TITLE SHEET	1
SHEET INDEX, ENGINEERS SEALS & CITY OF COLUMBUS SIGNATURES	2
PLAN LEGEND & DESIGN DESIGNATIONS	3
SCHEMATIC PLAN	4 - 7
GEOMETRIC PLAN	8 - 12
CURVE DATA	13 - 16
REFERENCE POINTS AND BENCHMARKS	17
CONTROL POINT KEY MAP	18
INTERSECTION DATA TABLE	19
TYPICAL SECTIONS	20 - 52
GENERAL NOTES	53 - 69, 66A, 67A, 68A, 69A, 69B
SUMMARY OF 4R PART 1 / 6R PART 2	
MOT SEQUENCING	69C
MAINTENANCE OF TRAFFIC	70 - 210, 71A, 71B, 78A, 81A, 102A, 159A-159C, 189A - 189P
GENERAL SUMMARY	211 - 218
SUBSUMMARIES	219 - 229, 225A
ESTIMATED QUANTITIES	230 - 255, 252A, 252B
CALCULATIONS	256 - 260
PROJECT SITE PLAN	261 - 264
PLAN AND PROFILE - I-70 EB	265 - 303
PLAN AND PROFILE - I-71 NB	304 - 315
PLAN AND PROFILE - RAMP A5	316 - 323
PLAN AND PROFILE - FUTURE RAMP B5	324
PLAN AND PROFILE - RAMP C3	325 - 330
PLAN AND PROFILE - RAMP C5	331 - 361
PLAN AND PROFILE - RAMP C6	362 - 367
PLAN AND PROFILE - FRONT STREET	368 - 369
PLAN AND PROFILE - FULTON STREET	370 - 371

NO.	DESCRIPTION	REV. BY	DATE
1	UPDATED SHEETS	CWL	11-5-2021
2	UPDATED SHEETS	CWL	11-12-2021

CALCULATED ATR CHECKED CWL
SHEET INDEX, ENGINEERS SEALS & COLUMBUS SIGNATURES
FRA-70/71-12.68/14.86
2
1815

PLAN AND PROFILE 36" (EAST)
 STA. 0+00 TO STA. 3+50

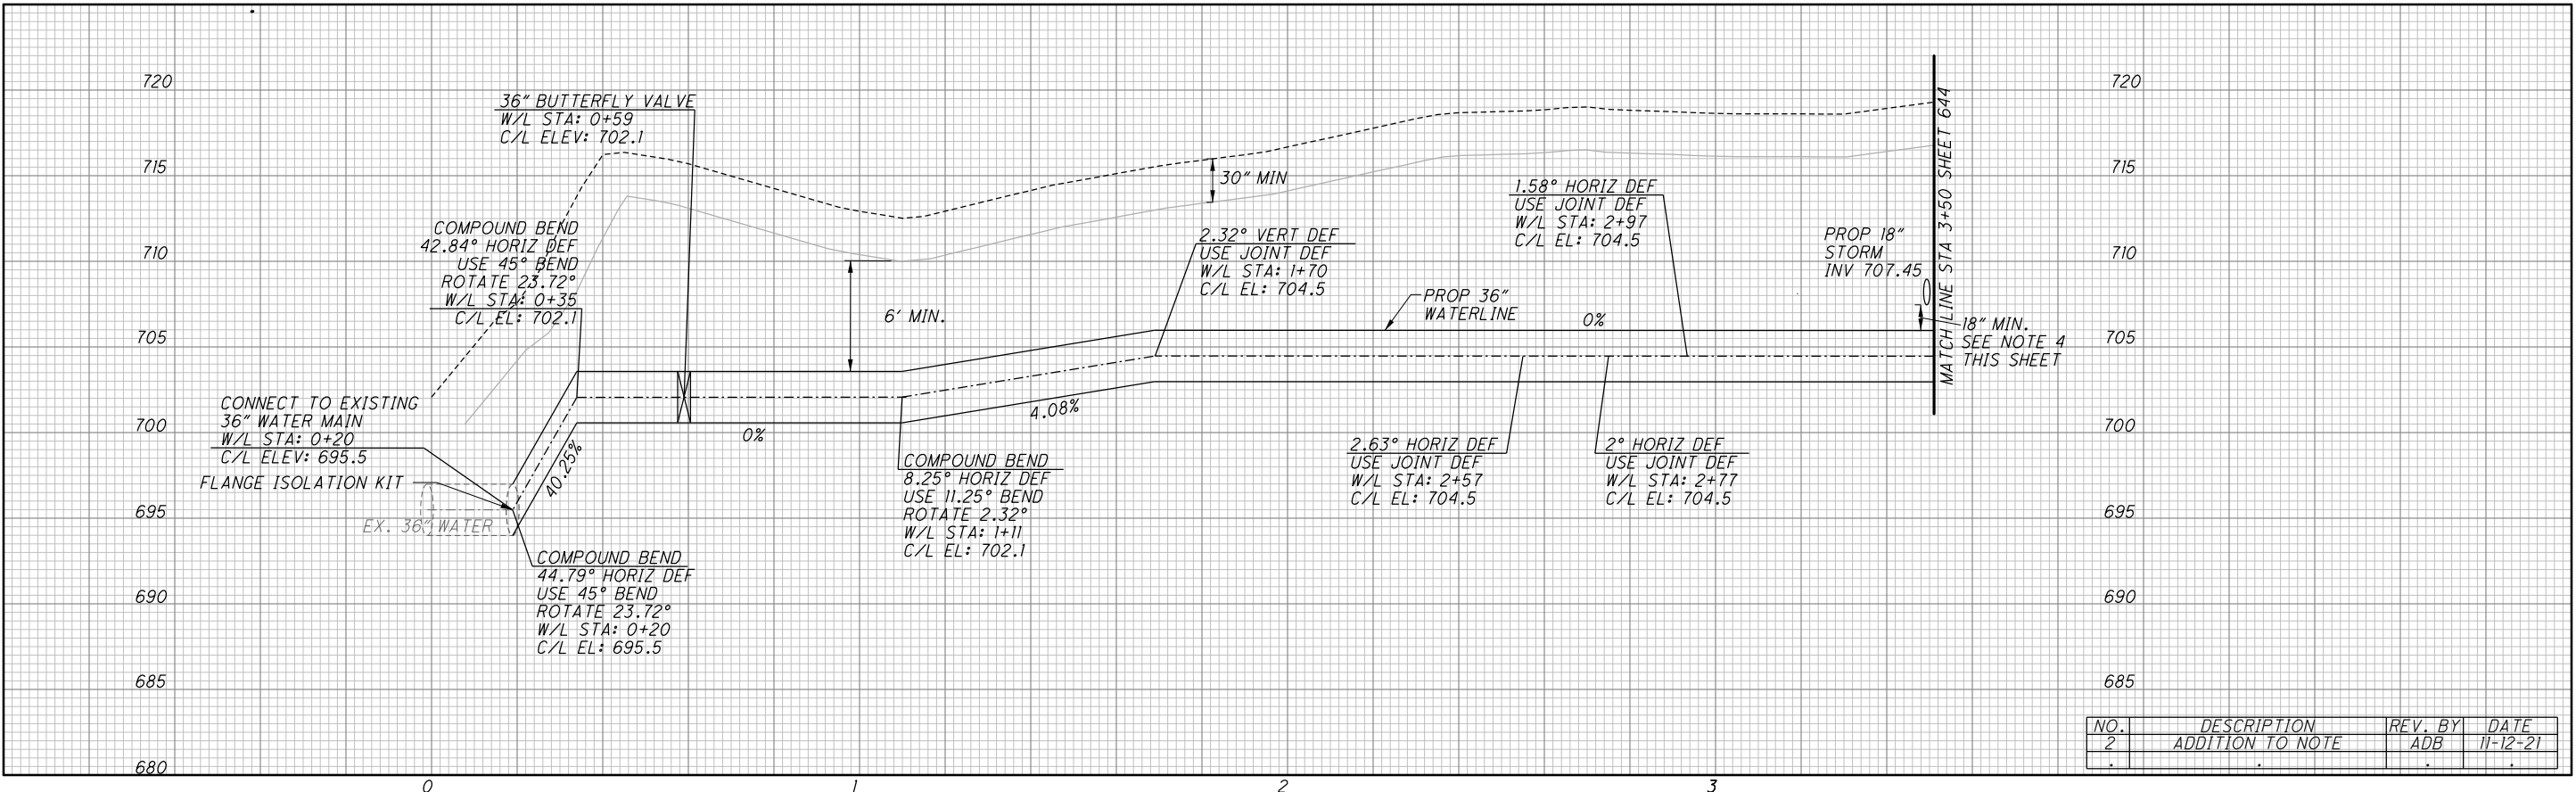
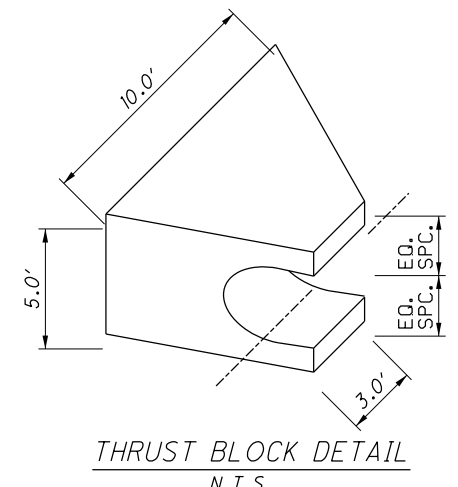
NO.	DESCRIPTION	REV. BY	DATE
2	ADDITION TO NOTE	ADB	11-12-21

NOTE:
 RESTRAINED JOINT LENGTHS ON SHEET 642
 APPLY ONLY TO PROPOSED 36-INCH WATERLINE.

STRUCTURE LOCATION MAP - PHASE 6R
BRIDGES AND RETAINING WALLS

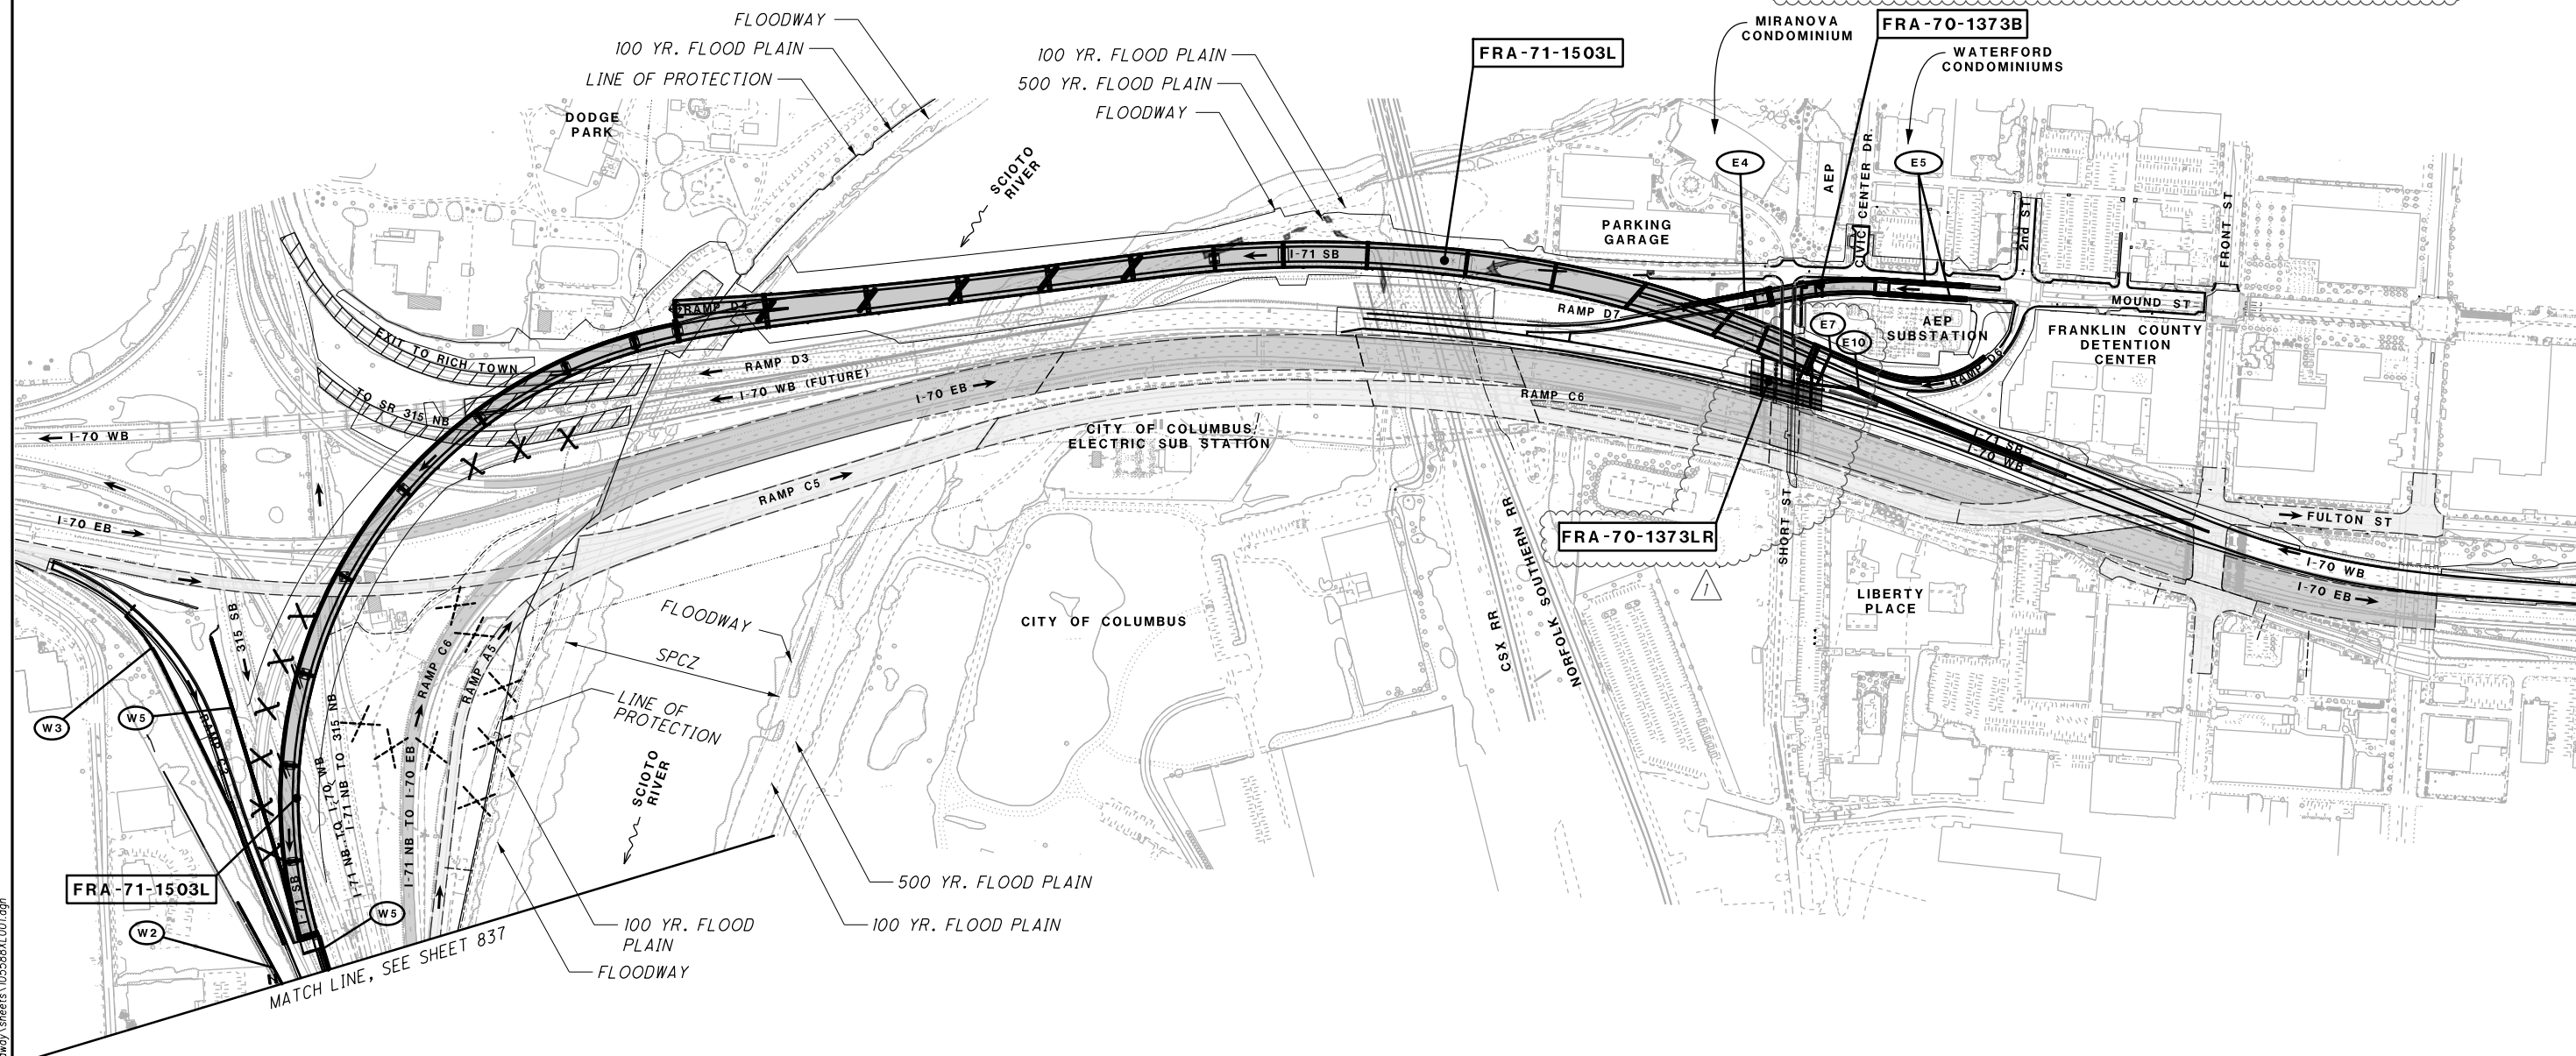
NO.	DESCRIPTION	REV. BY	DATE
1	Revise for Wall and Bridge Callout	TAZ	11-05-2021
